WATERBURY FILING NO. 1

CONSTRUCTION SET

GRADING AND EROSION CONTROL PLAN

REVISIONS	
NO.	DESCRIPTION

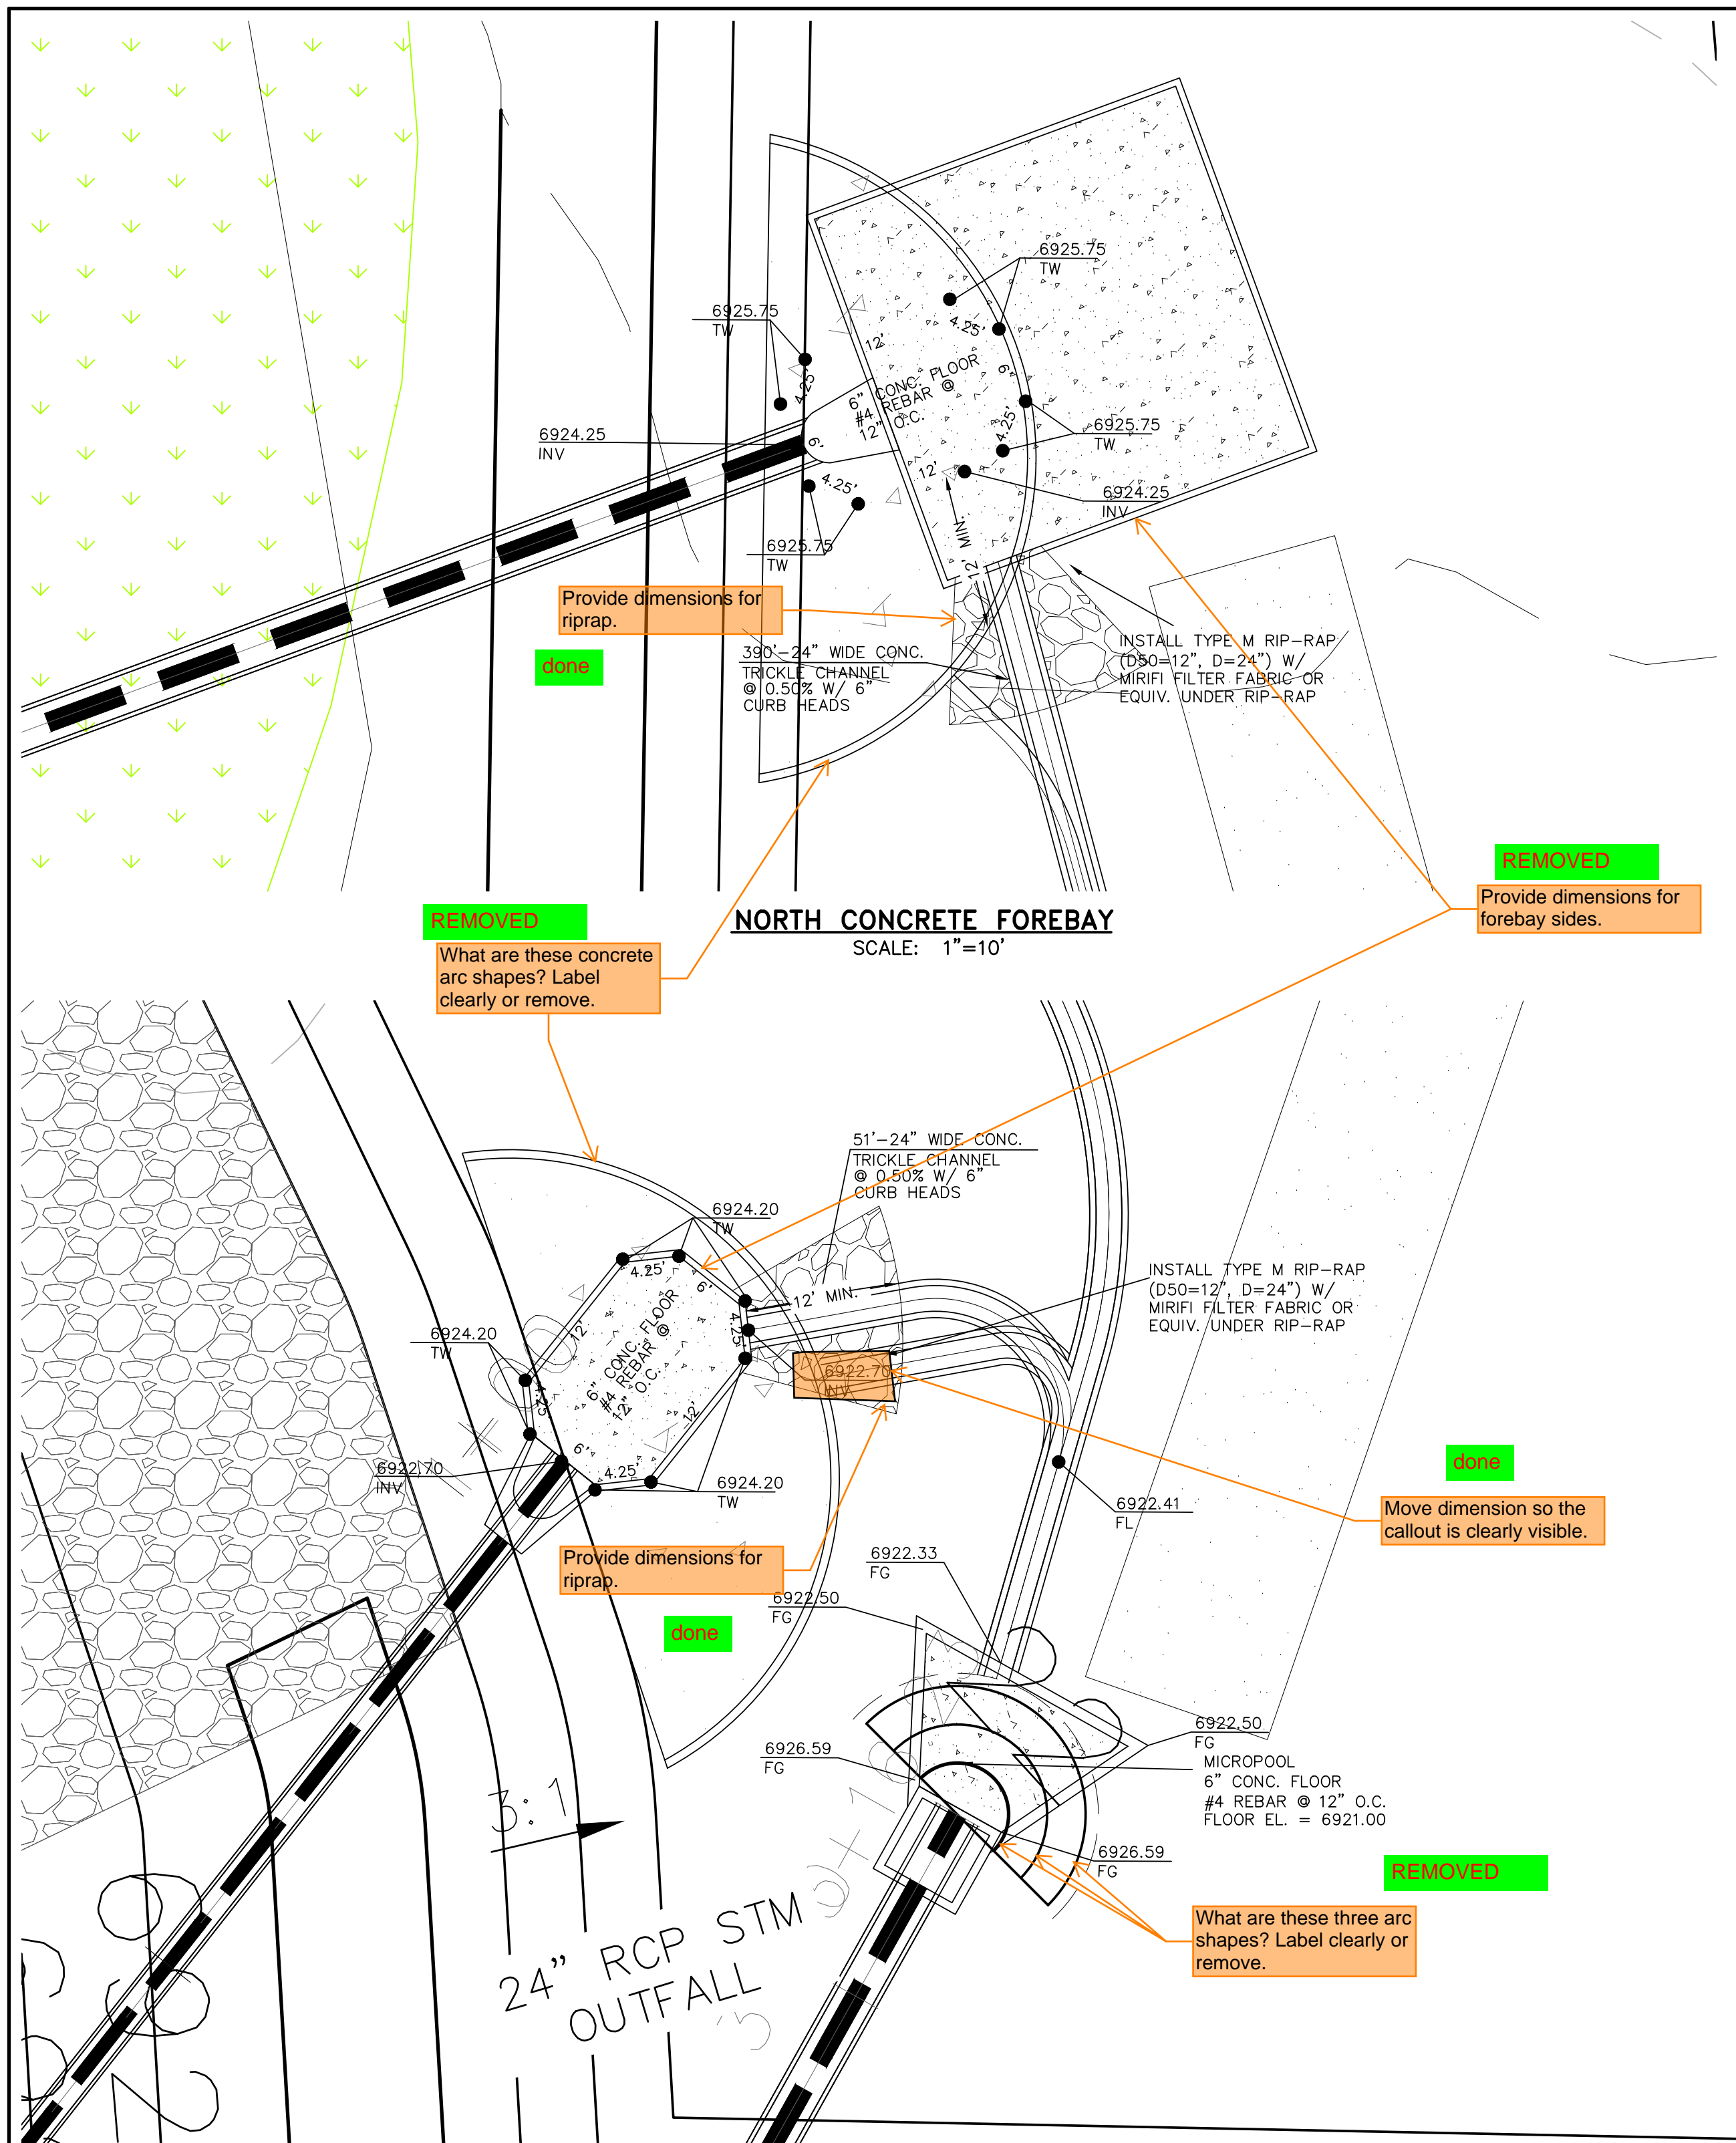
Does not match detail below or what is shown in DR calcs. Revise to remove discrepancy.

Does not match the DR. Verify and update so both match.
